INCH-POUND
MIL-PRF-55339/18
AMENDMENT 1
23 February 1979

PERFORMANCE SPECIFICATION

ADAPTER, CONNECTOR, COAXIAL, RADIO FREQUENCY,
(BETWEEN SERIES BNC TO SERIES N), CLASS 2, STRAIGHT PLUG

This amendment forms a part of Performance Specification MIL-PRF-55339/18, dated 6 May 1975, and is approved for use by all Departments and Agencies of the Department of Defense.

FIGURE 2, delete and substitute:

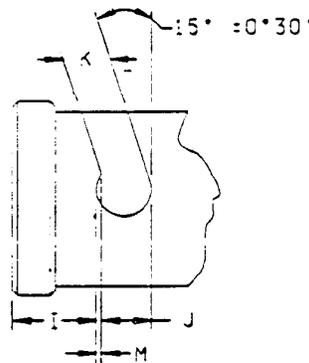
FIGURE 2, maximum column: Add dimension E ".230 (5.84)", dimension L ".040 (1.02)", and dimension P ".228 (5.79)".
